SB-GA8-2003-05

Service Bulletin

Conversion of aircraft from CASA certificated FAR23 Amendment 54 status to FAA certificated FAR23 Amendment 54 status.

Figure 1 - Pitch stop attachment

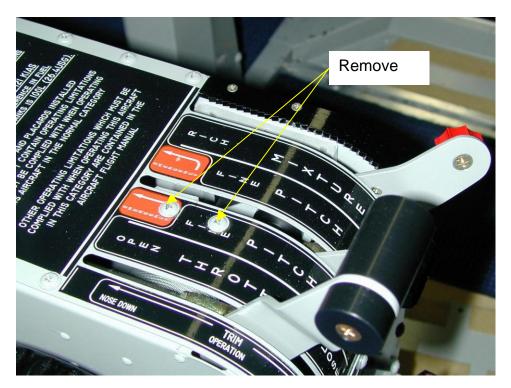
To meet noise requirements under the ICAO test method accepted by CASA, the aircraft features a pitch stop to limit propeller speeds to 2500 rpm for normal operations with an emergency bypass to 2700 rpm.

The FAR 36 noise test method accepted by the FAA results in no limits on propeller speed below the maximum allowable value of 2700 rpm, and so the pitch stop can be removed.

- 1. Gain access to the throttle quadrant by removing the access panel on the left hand side of the centre console.
- 2. Unfasten the two screws attaching the pitch stop and backing plate to the throttle quadrant cover. Discard these parts.

Figure 3 - Tachometer marking

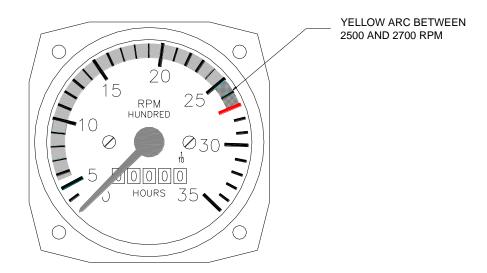
1. Remove existing tachometer and replace with new tachometer (P/N GA8-771013-9).

Alternatively, the existing tachometer may be reworked by re-marking the existing red arc between 2500 rpm and 2700 rpm with a yellow arc. Refer to Figure 3. Re-identify the tachometer as GA8-771013-9.
